DRAINAGE INFORMATION SHEET

RE: DRAINAGE PLAN FOR LOVELACE STORAGE BUILDINGS
(L-18/D33) REVISION DATED MAY 24, 1990

DRAINAGE / GRADING PLAN
5211 GIBSON BLVD. S.E.

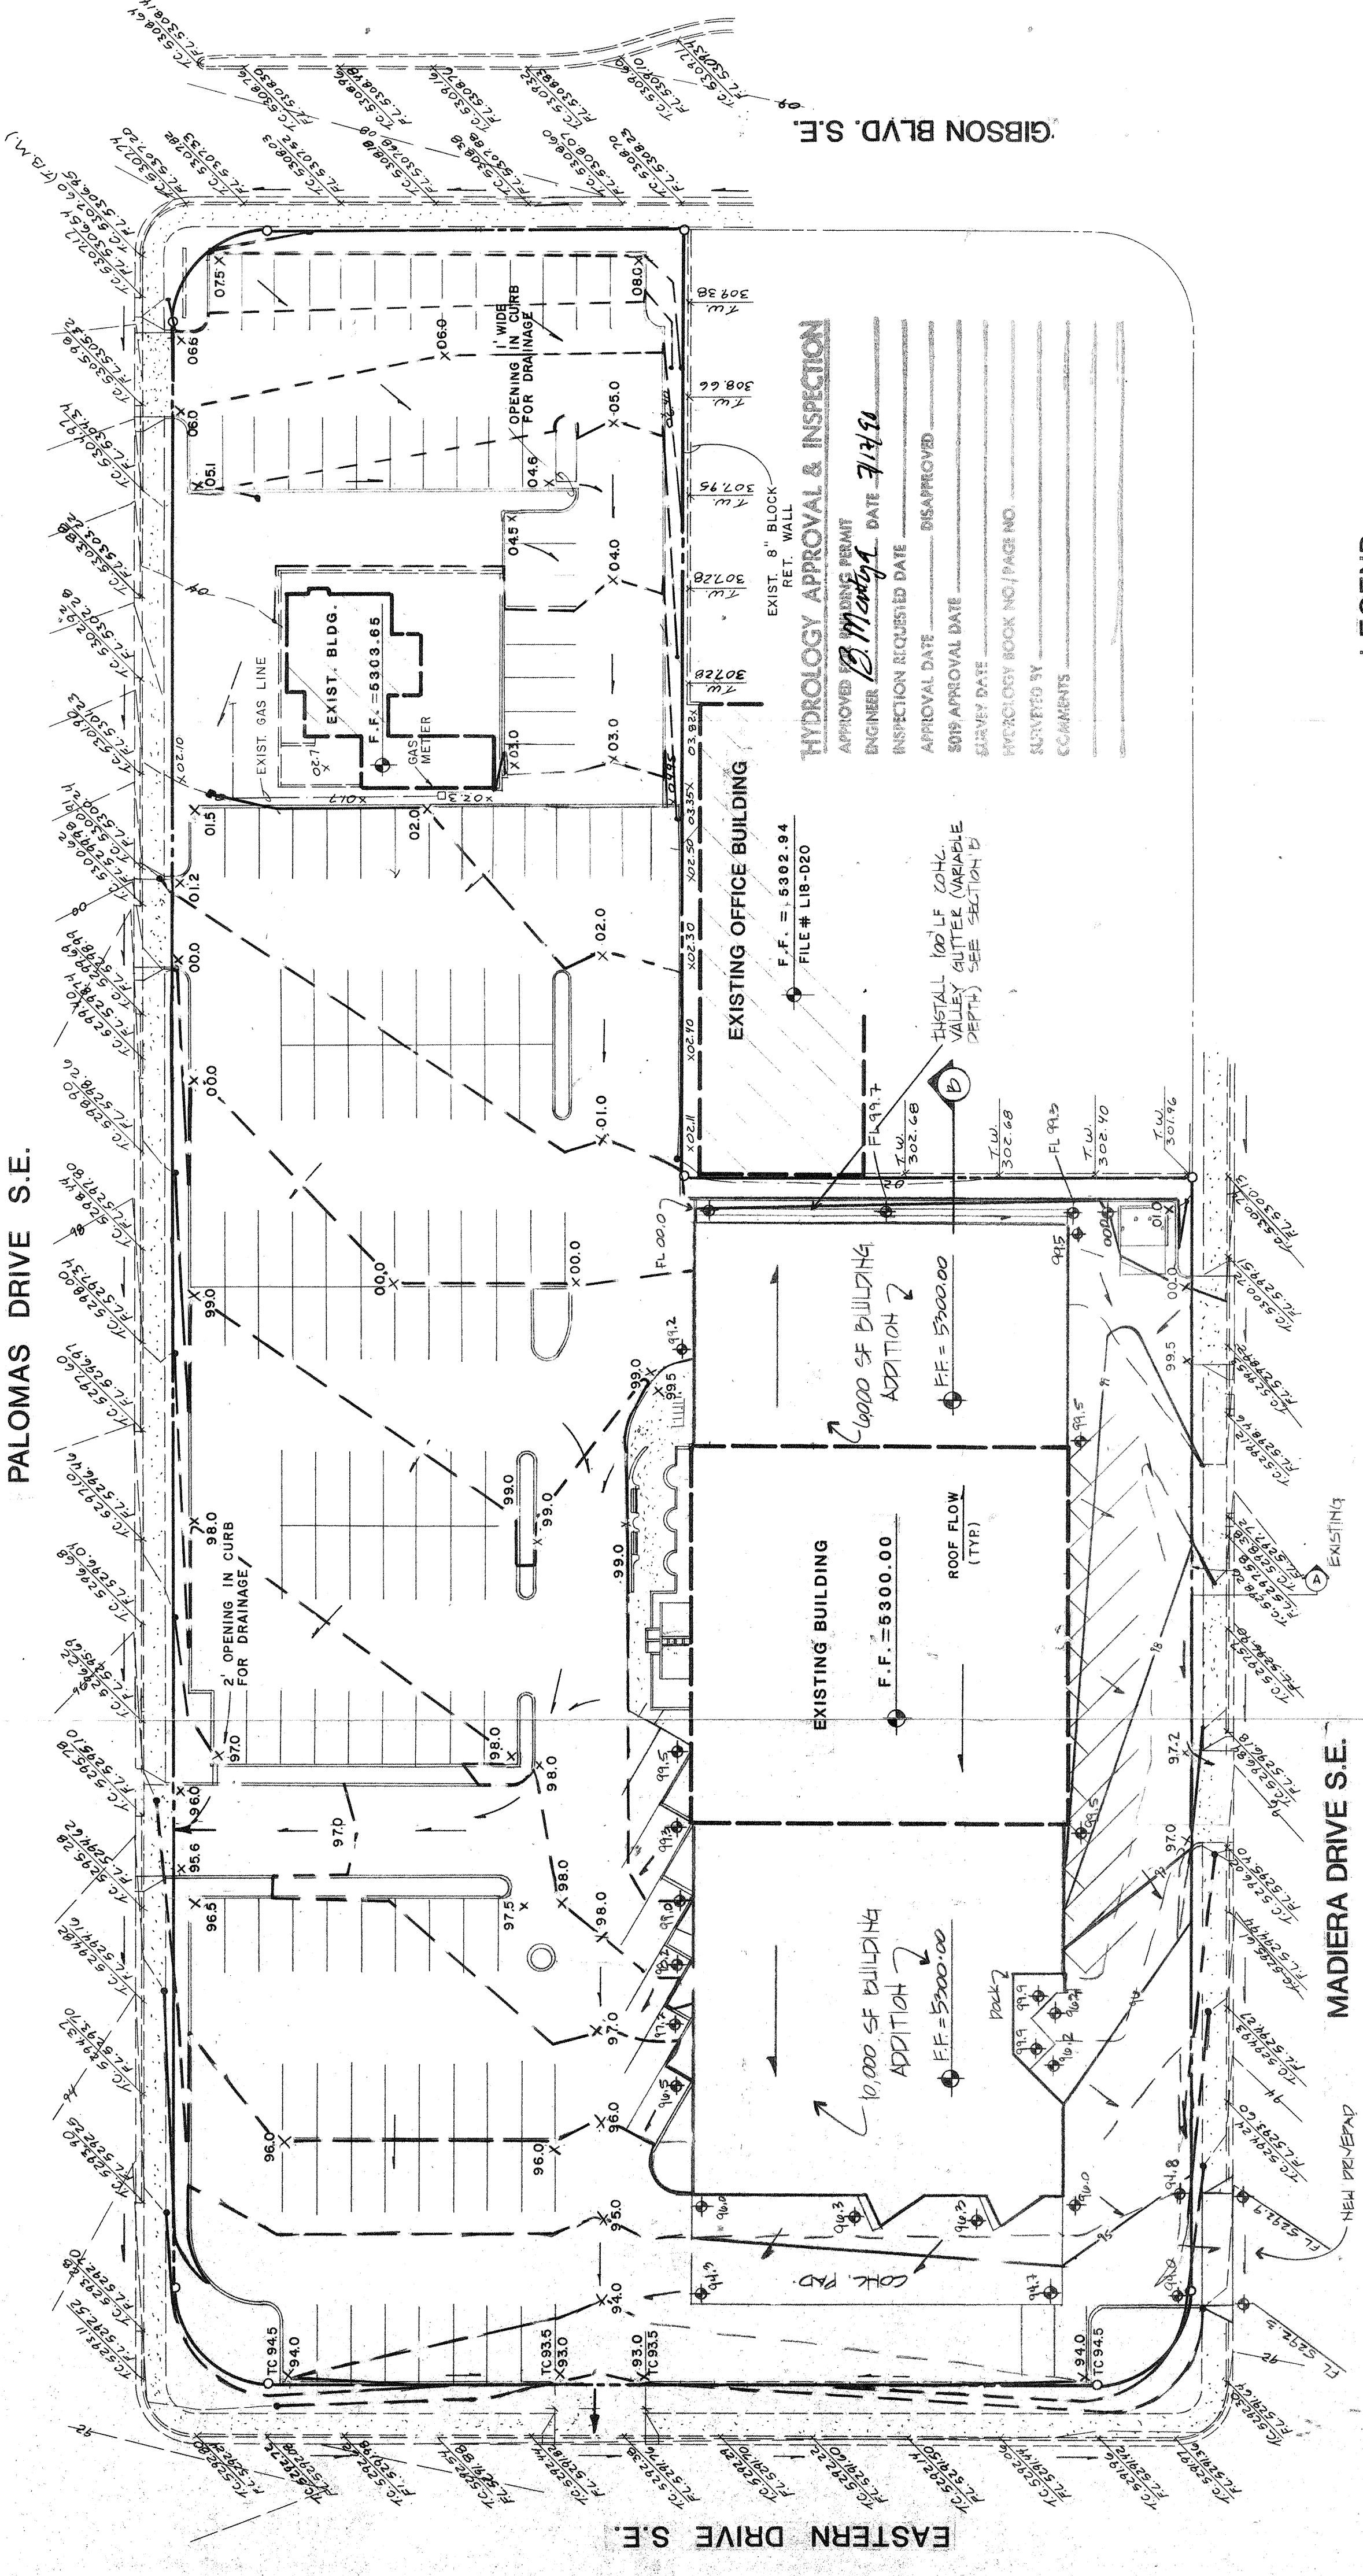
Based on the information provided on your submittal of JULY 10, 1990, the above referenced plan is approved for Site Development and Building Permit.

Please attach a copy of this plan to the construction sets prior to sign-off by Hydrology.
